# DCBX PFC Configuration

Issues and proposals to clarify use of DCBX for PFC Configuration.<sup>1,2</sup>

Mick Seaman

Figure 1-1—Symmetric state machine

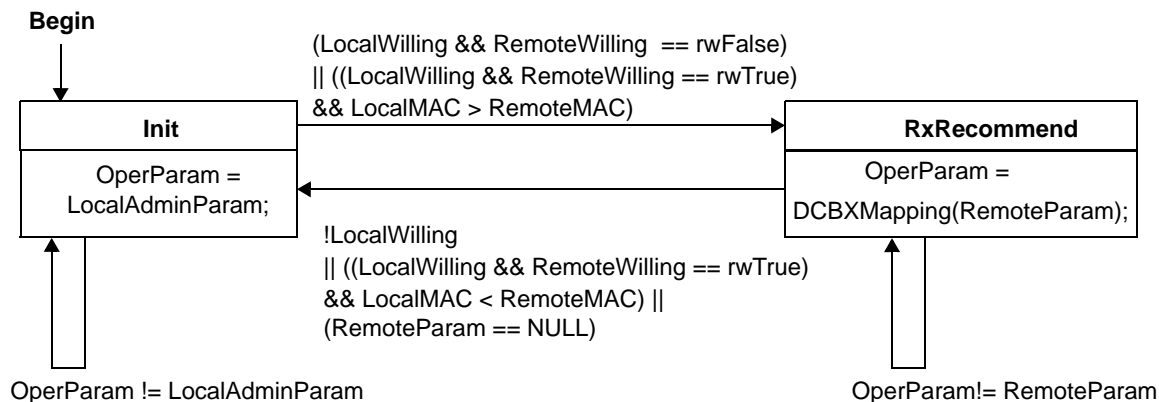
- Start-up behavior unspecified. One peer can decide to delay use of the link, while the other believes it to be operational immediately. Can PFCs be sent immediately (potential storm) or not? Pending as defined can be true for ever.
- If !LocalWilling and Remote has PFC capability constraints, Pending can be permanently True.
- State machine transition choice unspecified if two are possible, so RxRecommend can spin lock if DCBXMapping is not trivial identity function. Similarly Init can spin lock, defeating parameter updates.
- Defined value 'rwNull' not used, 'RemoteParam == NULL' instead, does not match prior description.
- No behavior defined for '!LocalWilling && !RemoteWilling' - agree to disagree.
